NO.	DESCRIPTION	DATE
3	PERMIT REVISION 1	04.19.22
4	REV 1 SUB 2	06.10.22
5	REV 1 SUB 3	08.30.22
6	PERMIT REVISION 2	07.06.23
7	PERMIT REV. 2 SUB 2	11.07.23

CLARKSON RESIDENCE
8163 WEST MERCER WAY
MERCER ISLAND, WA 98040
© COPYRIGHT 2022 BRANDT DESIGN, INC. SEATTLE, WA

PERMIT DRAWINGS

1 PROPOSED SITE PLAN
1" = 10'-0"

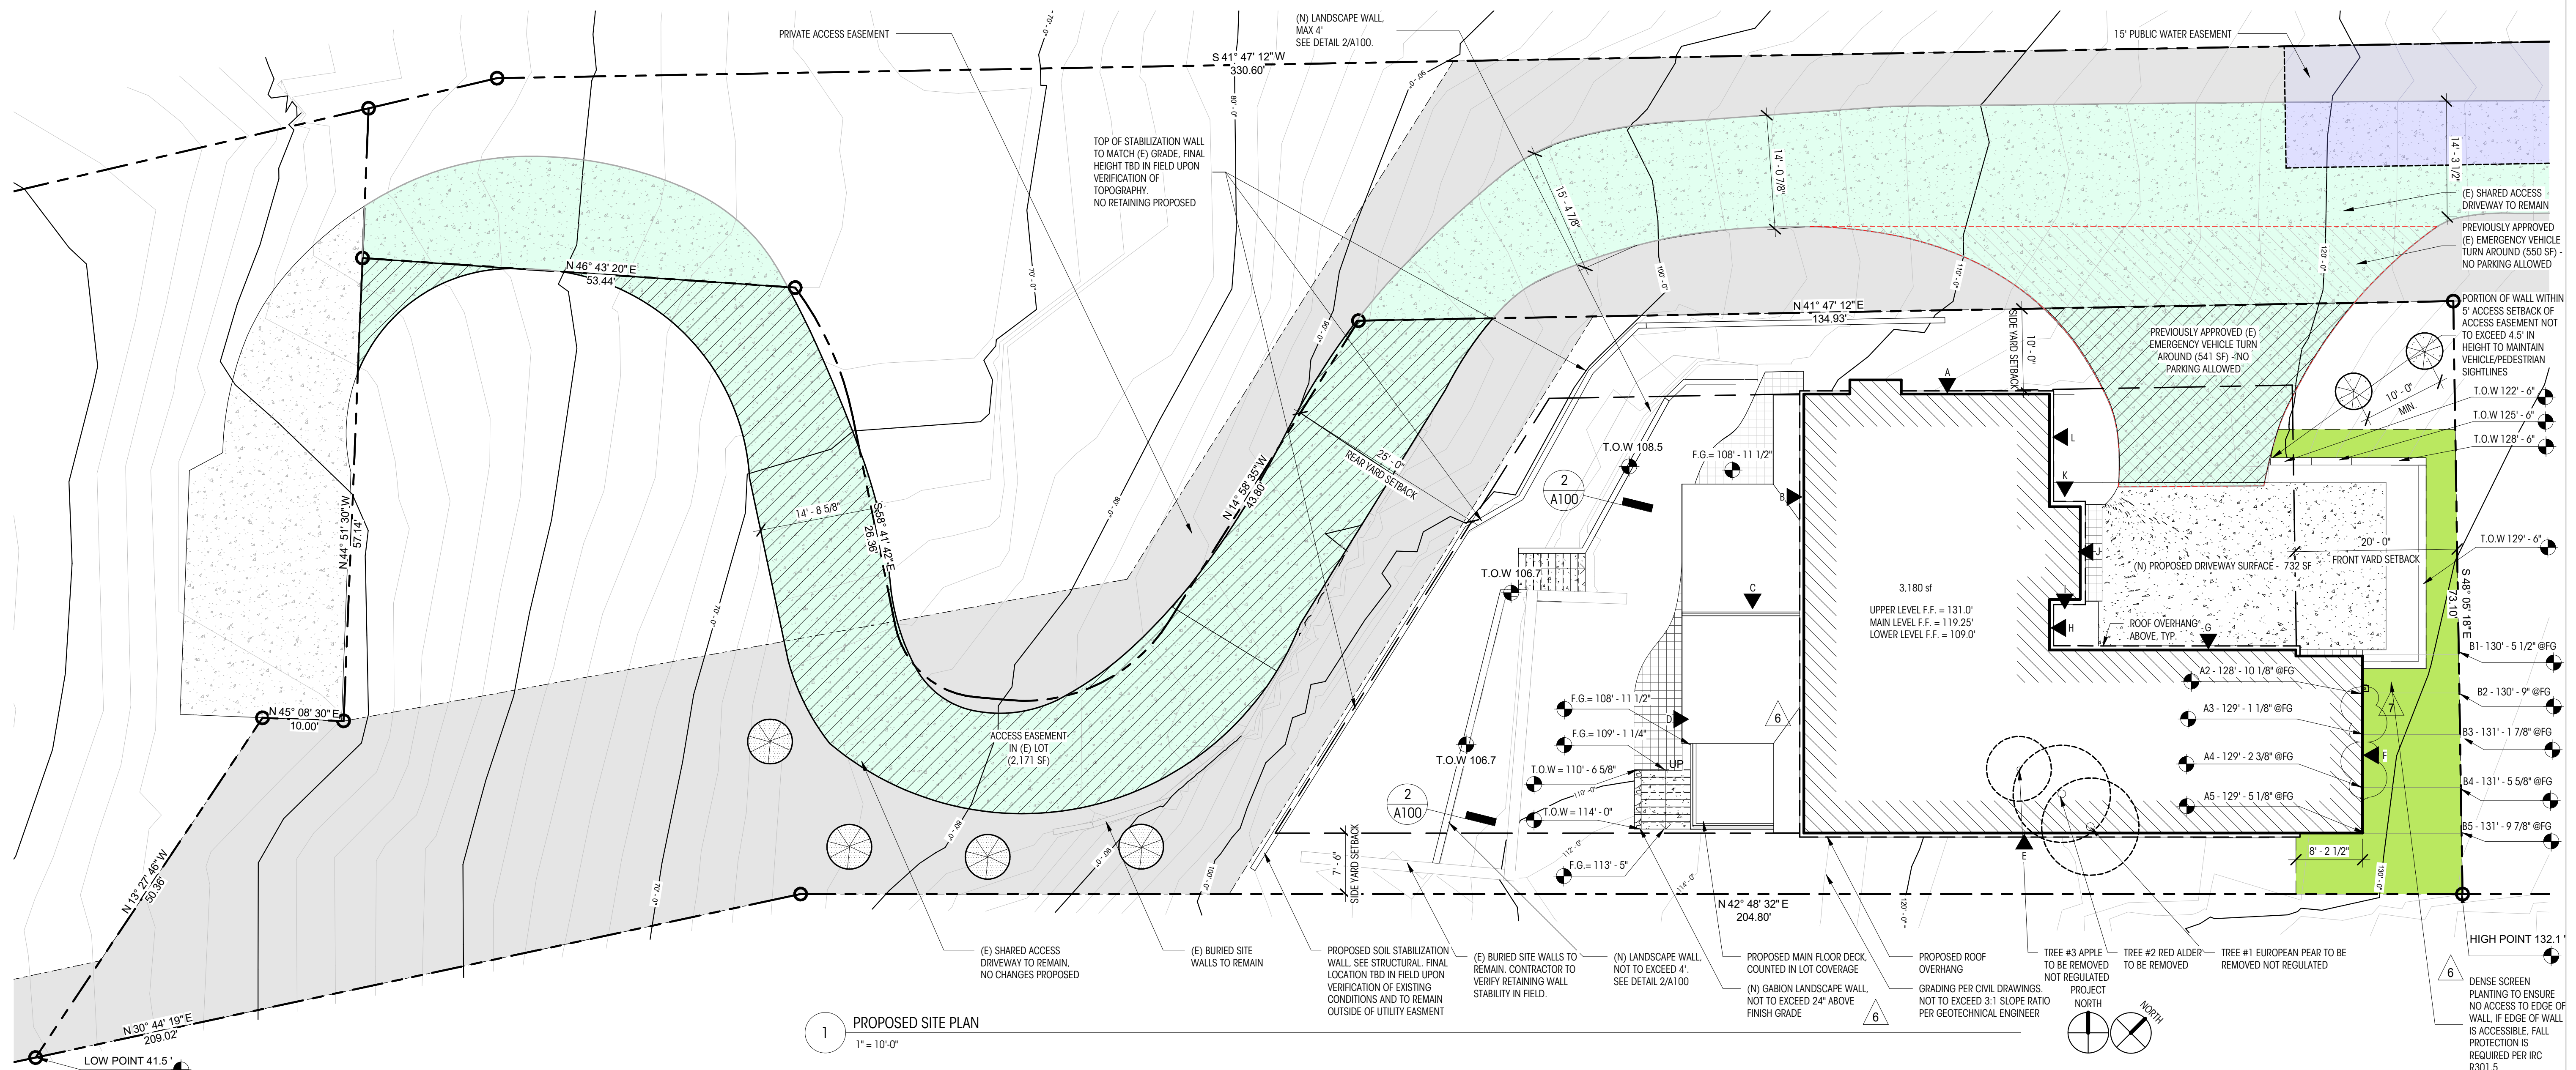
SCOPE OF CHANGES:

- UPDATES TO GFA, LOT COVERAGE & HARDSCAPE CALCS
- REDUCTION OF MOTORCOURT PAVING.

CRITICAL AREA & TREE PLAN

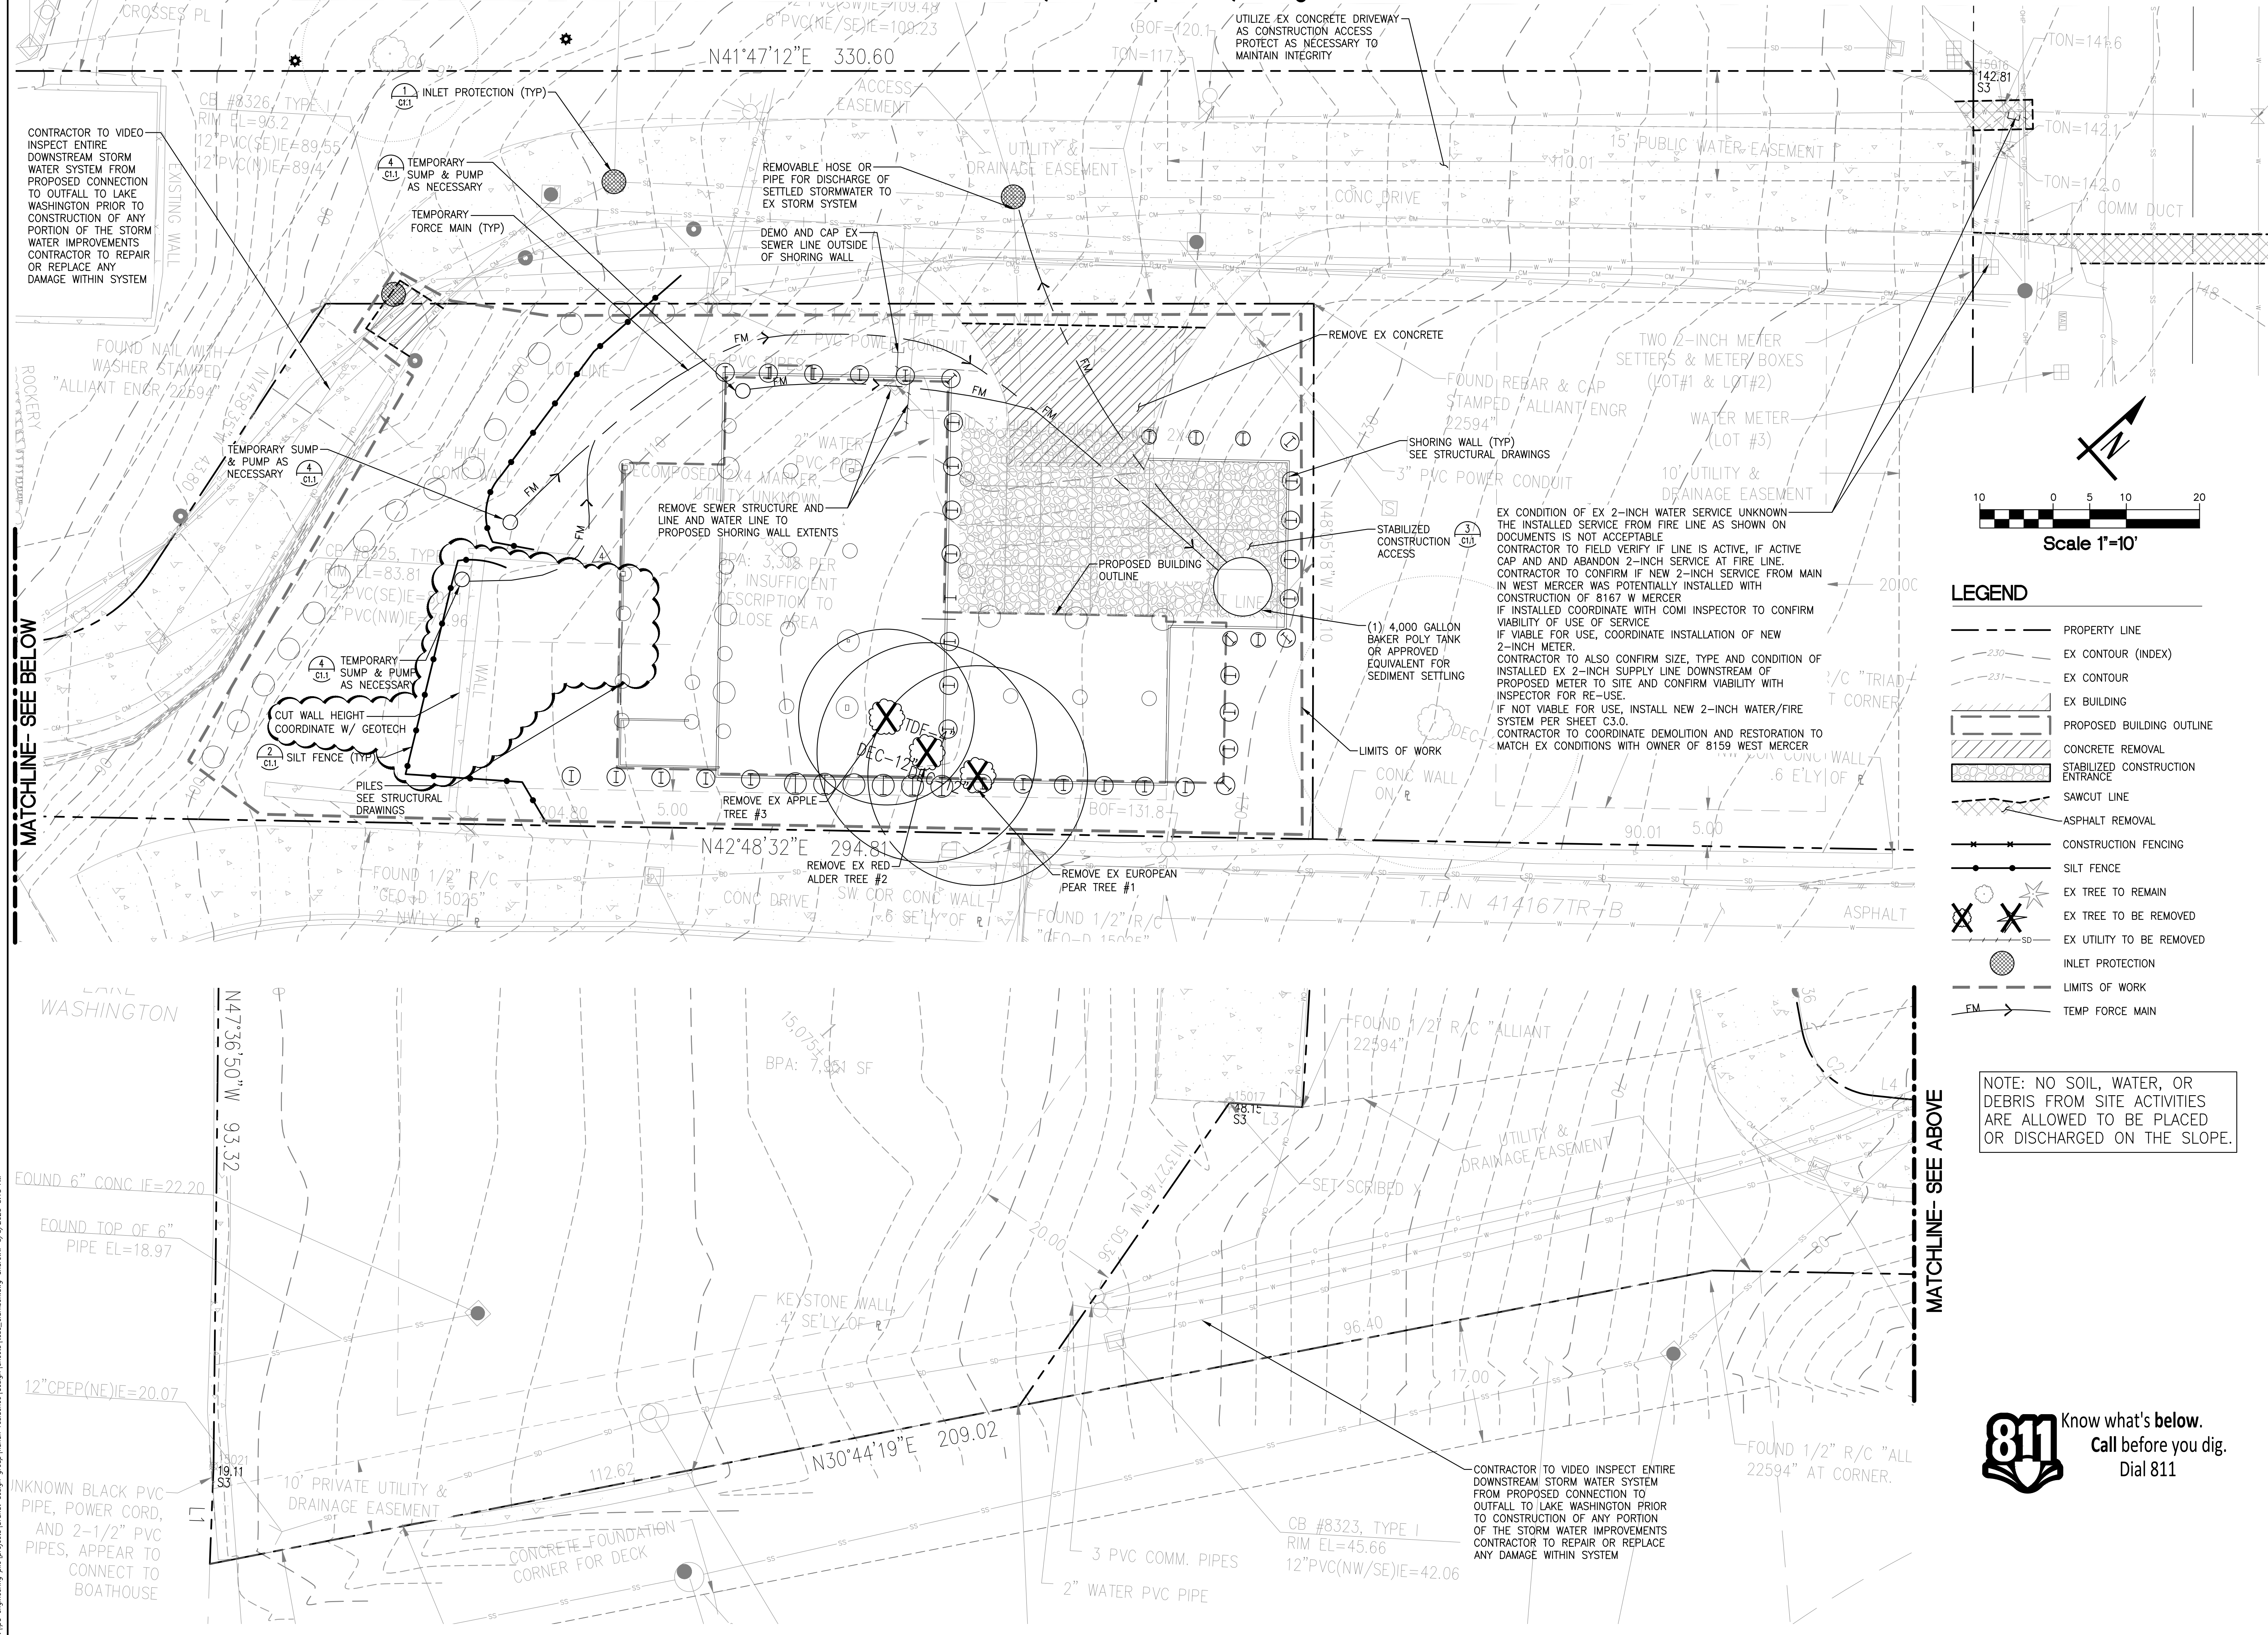
SCOPE OF CHANGES:

- 7 DENSE SCREEN PLANTING GRAPHIC ADDED BACK IN

PROPOSED LOWER LEVEL FLOOR PLAN
1/4" = 1'-0"

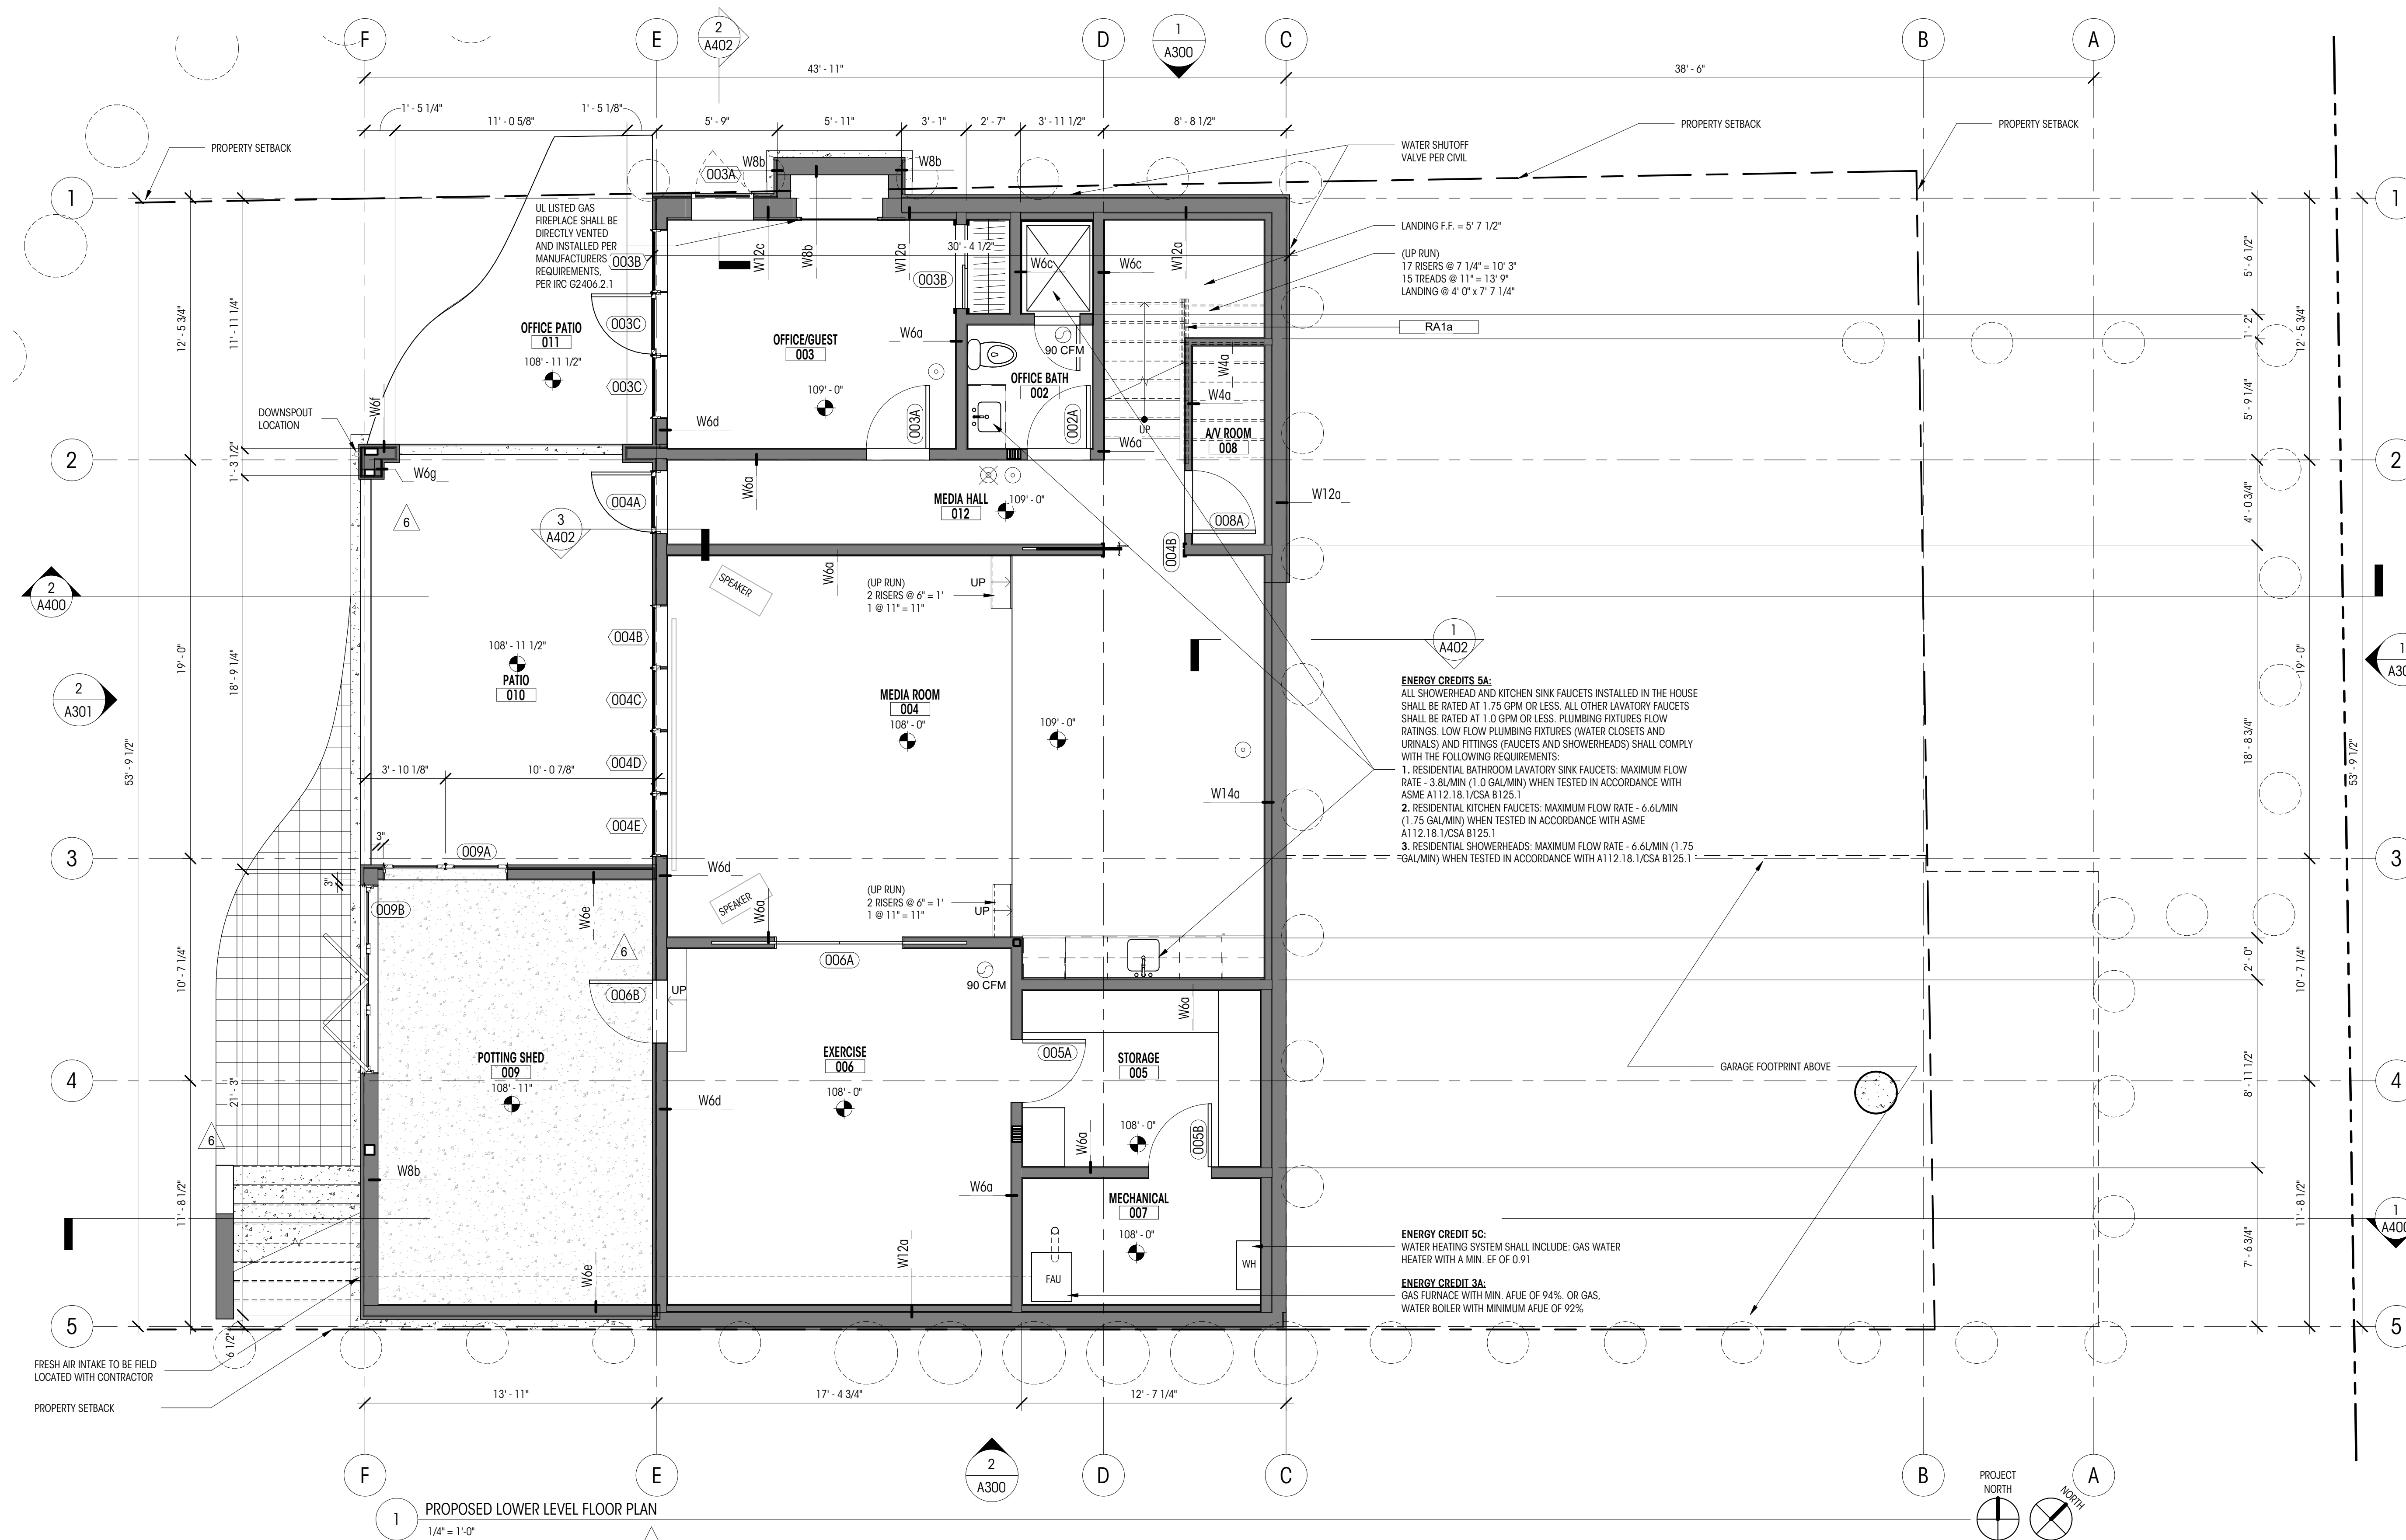
SCOPE OF CHANGES:

UPDATE TO LOWER LEVEL BASEMENT GFA REDUCTION PER PERMIT COMMENT.
